ADDENDUM

DYSART DRAIN IMPROVEMENT PROJECT

Concept Design Study Selected Alternative

Prepared for:
FLOOD CONTROL DISTRICT OF MARICOPA COUNTY

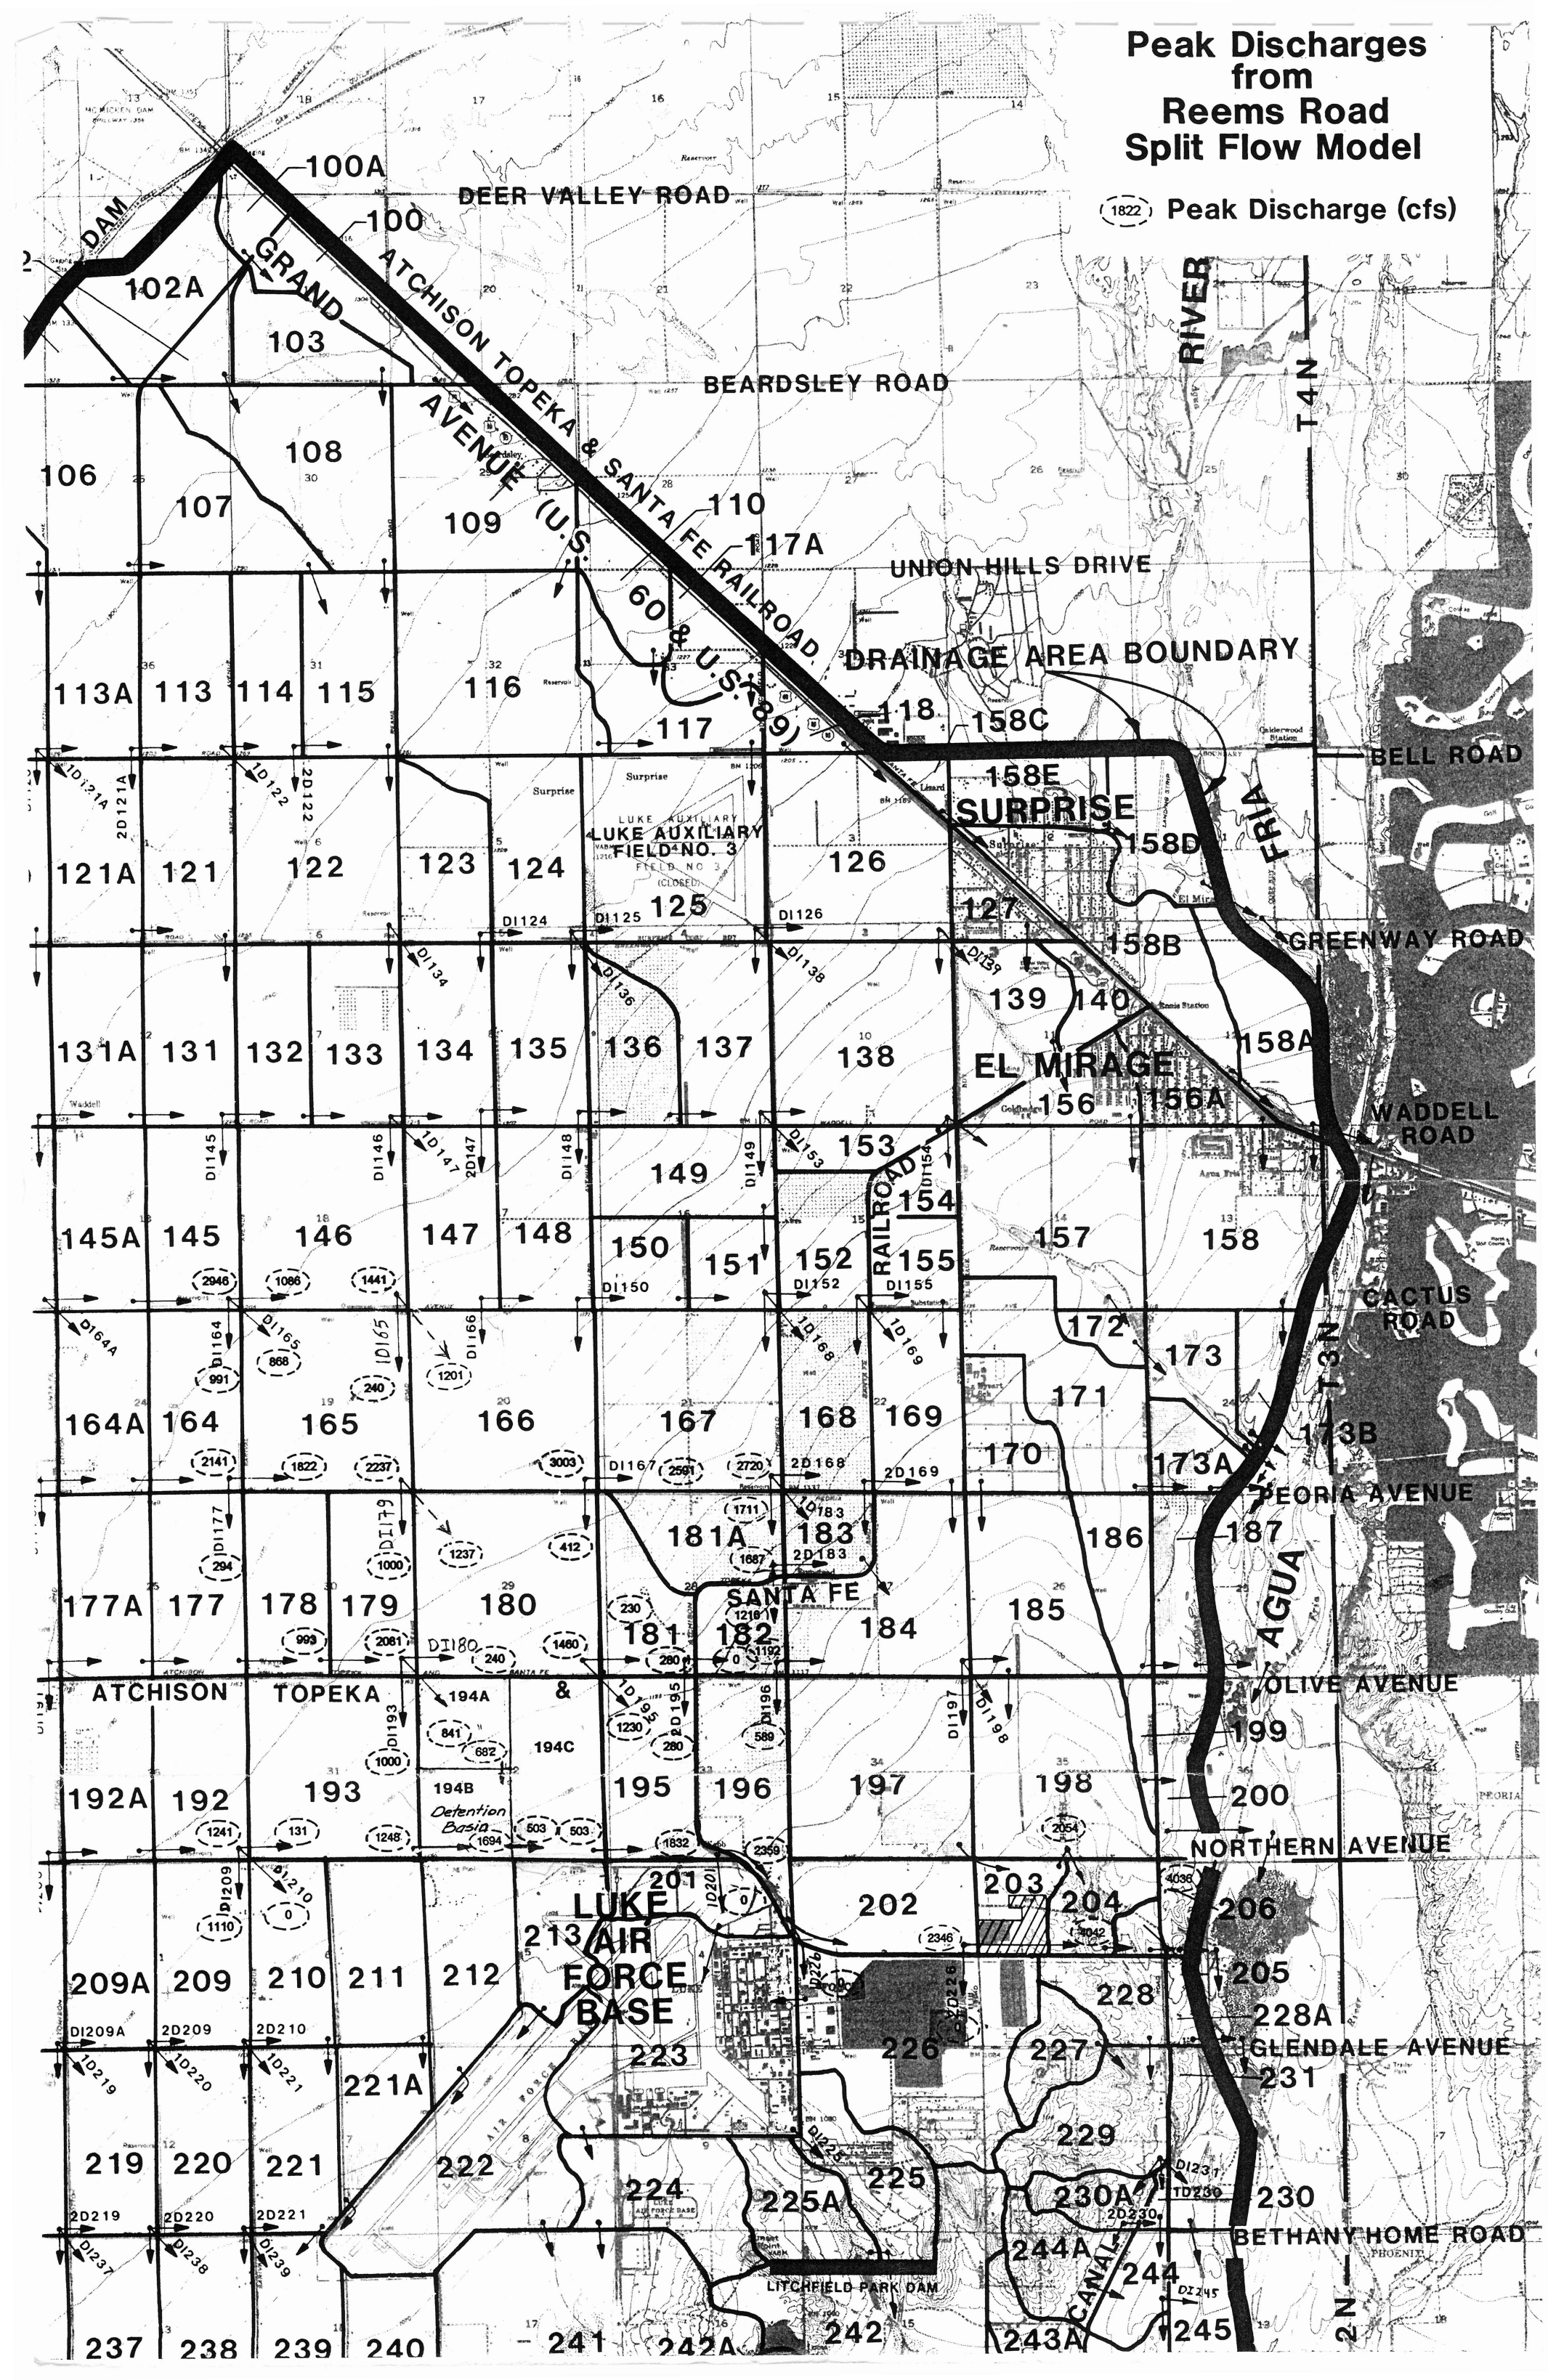
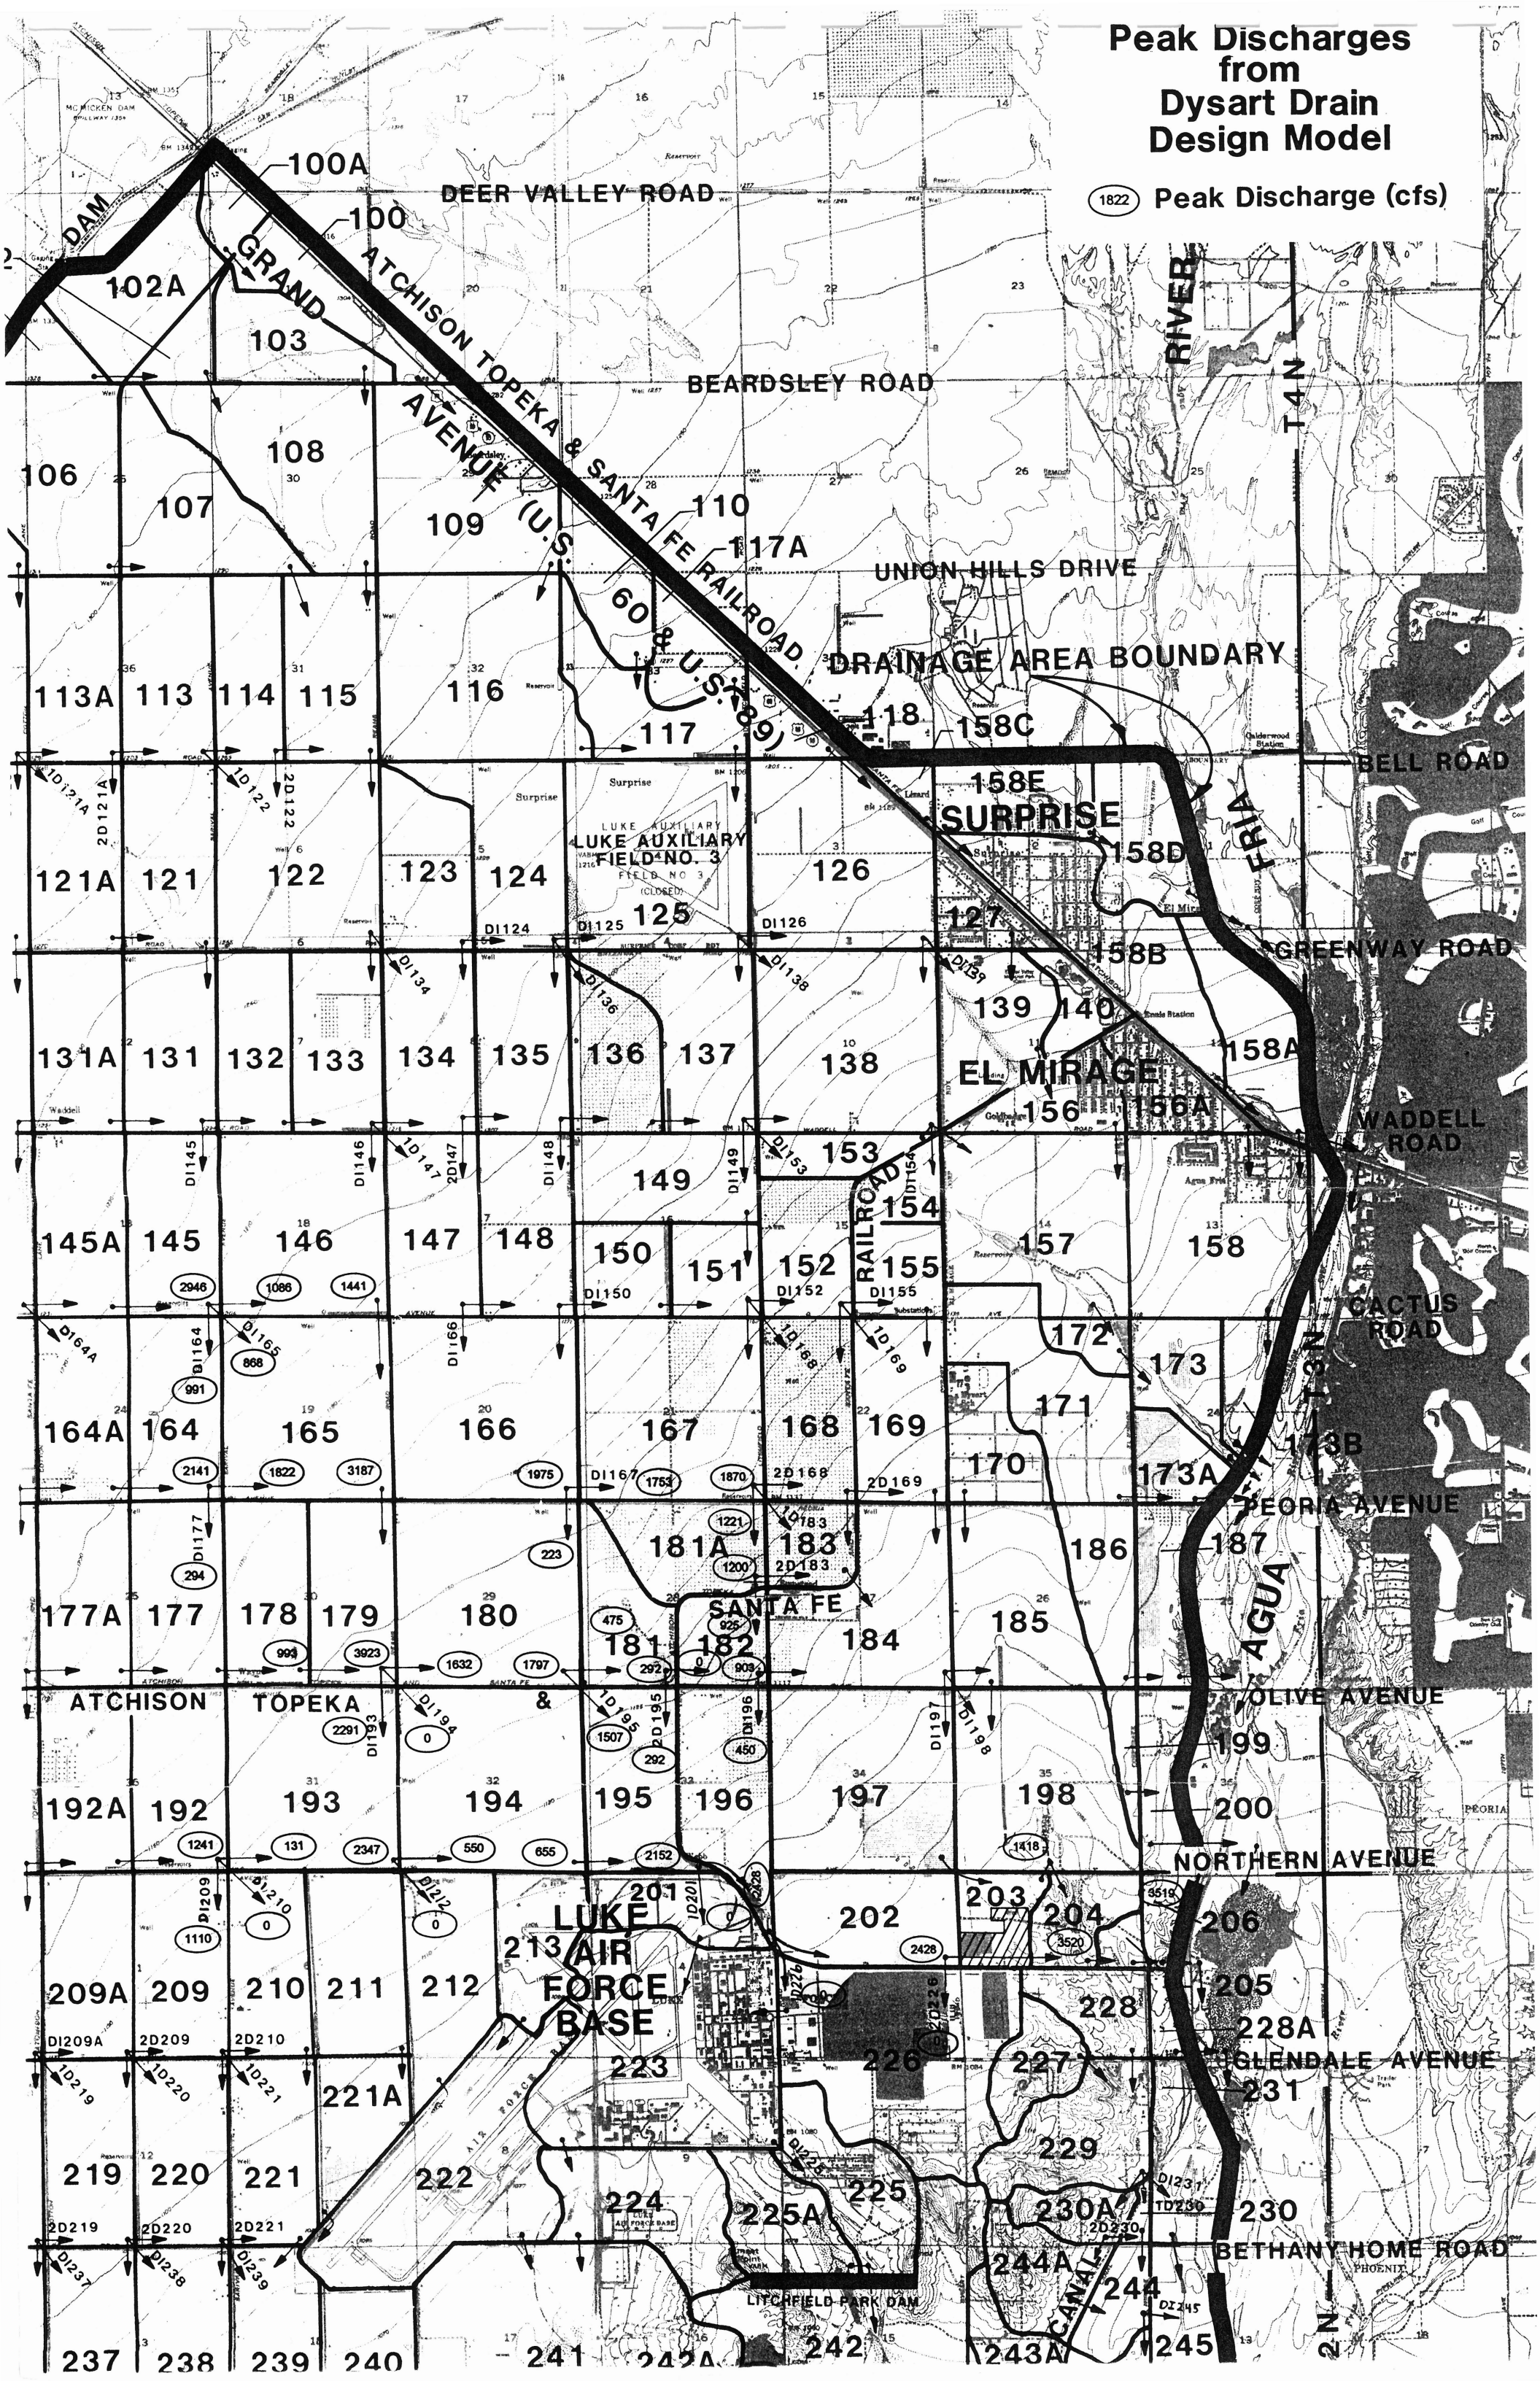
The peak discharges from the Reems Road split flow model are presented on the following exhibit. A second exhibit is also included which presents the design flows for Dysart Drain. The HEC-1 split flow model (DYSMOD1A.24) is included in the back of this report on diskette.

The results of the split flow model indicate that 840 cfs will breakout and flow across the farm fields southeast of the intersection of Reems Road and Olive Avenue. In addition, significant breakouts occur along Reems Road at both Cactus Road and Peoria Avenue. The following paragraphs describe the effects that these split flows have on the proposed detention basin and the downstream channel improvement.

The split flow model results in a reduction in the channel peak discharges for most of the length of the channel. From the basin outlet downstream to the inflow spillway, west of El Mirage Road, the peak discharges are 3% to 23% lower than the design flows. From the inflow spillway out to the Agua Fria River (about 1/2 mile), the flow is increased approximately 15%. This increase is due to the fact that most of the flow that splits out of Reems Road, at Cactus Road, will be collected in the natural channel that enters Dysart Drain at the inflow spillway.

D. The design peak discharges for the Dysart Drain channel should be maintained. The split flow model indicates that the 100-year flows in the channel may be 3% - 23% lower than the design flows for most of the length of the channel. It seems reasonable to maintain the additional capacity to provide extra conveyance for the uncertainty in flow direction described above. Only in the last 1/2 mile of channel does the split flow model predict higher flows than the design peak discharges. In this reach there is more than adequate freeboard to contain the increase in flow.
